# PSL - PMC

## PMC Servo Rev E01

Engineering Change Order History		
ECO number	Date	Originator
1	E010166 to Rev C	RK
2	E010223 to Rev C1	RK
3	E010331 to Rev D	RK
4	E010332 to Rev E	RK
5

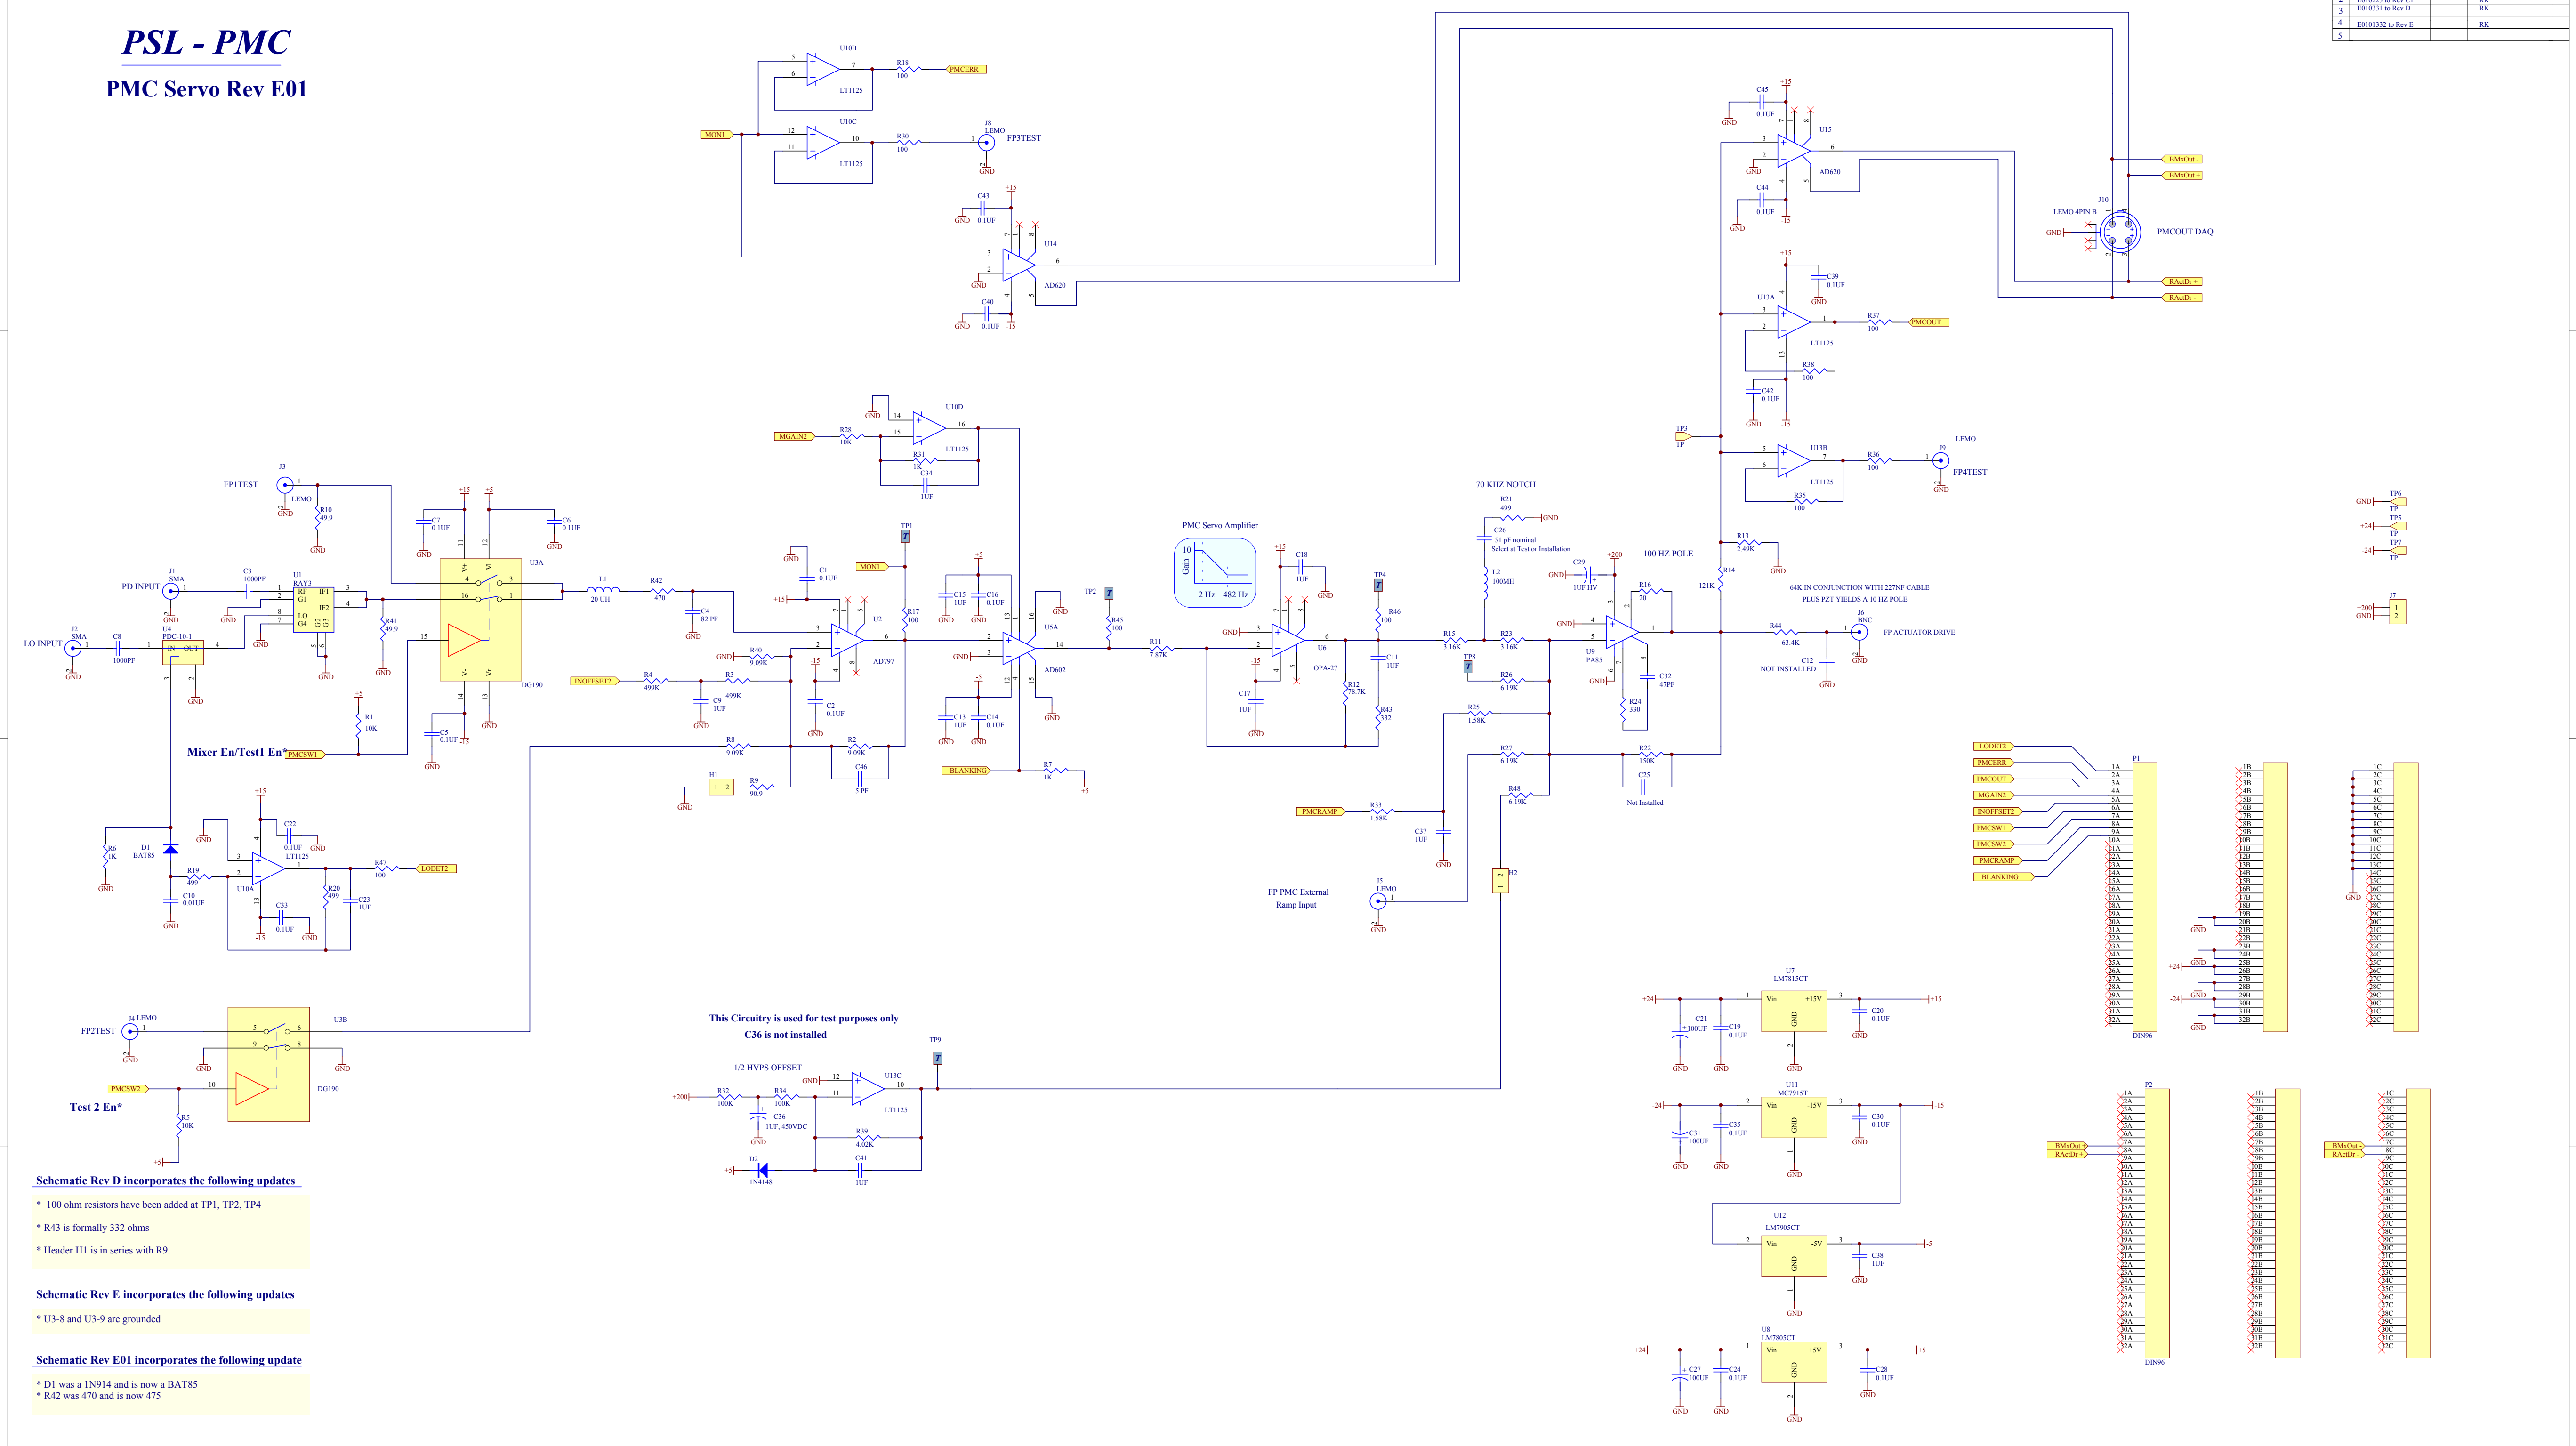
**Schematic Rev D incorporates the following updates**

- \* 100 ohm resistors have been added at TP1, TP2, TP4
- \* R43 is formally 332 ohms
- \* Header H1 is in series with R9.

**Schematic Rev E incorporates the following updates**

- \* U3-8 and U3-9 are grounded

**Schematic Rev E01 incorporates the following update**

- \* D1 was a 1N914 and is now a BAT85
- \* R42 was 470 and is now 475
